Subject: Governmental Facilities Hearing Application
GF09-09 Arcola Fire Rescue Station No. 67

From: Miami-Dade County Site Review Committee

APPLICATION GF09-09

MIAMI-DADE FIRE RESCUE
ARCOLA FIRE RESCUE STATION

SHEET NUMBER:
A-1.0

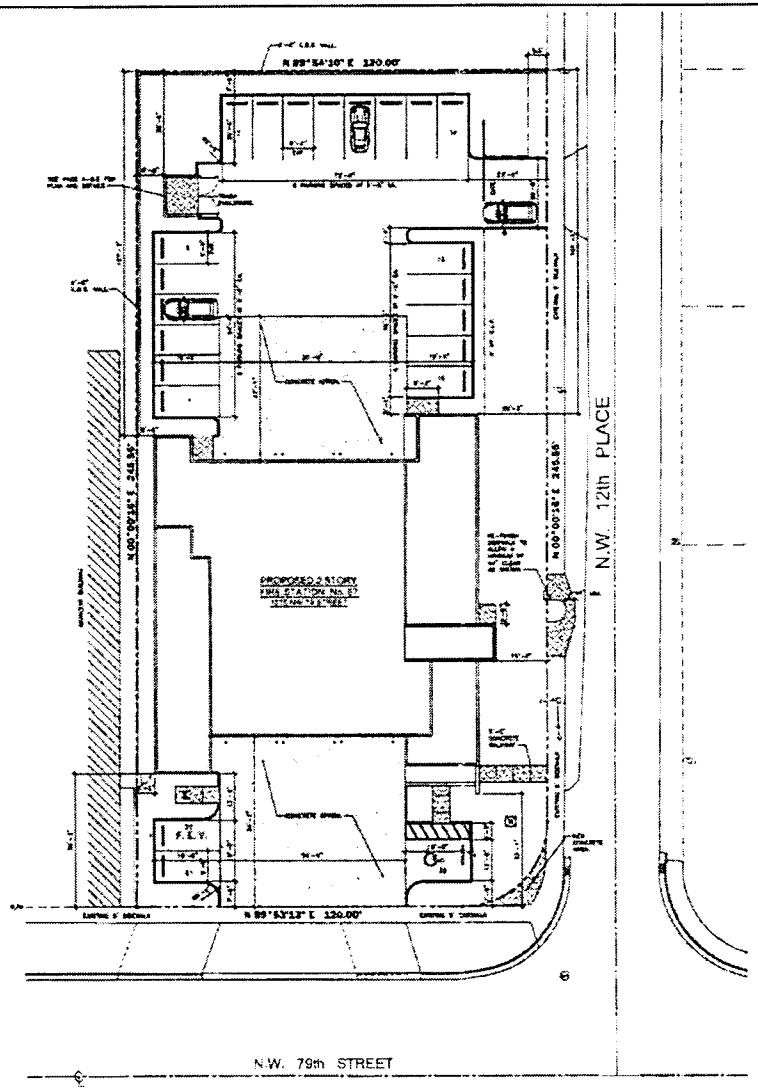
- Dumpster/Trash enclosure location does not appear to allow proper access for garbage truck. NW 12 Place vehicle entrance becomes blocked when truck is accessing dumpster.

Tree Removal Permit 2009-TREE-PER-00475 was issued to Miami-Dade County Fire Rescue Department on January 8, 2010 and is scheduled to expire on January 8, 2011. This permit requires the preservation of one specimen sized (trunk diameter 18 inches or greater) live oak tree in the right of way as identified in DERM-approved permitted plans. The tree removal plan submitted with this application entitled "Tree Removal Plan", sheet A-1.0, prepared by Angel H. Lamela, Architect and dated October 28, 2009, depicts this tree to remain.
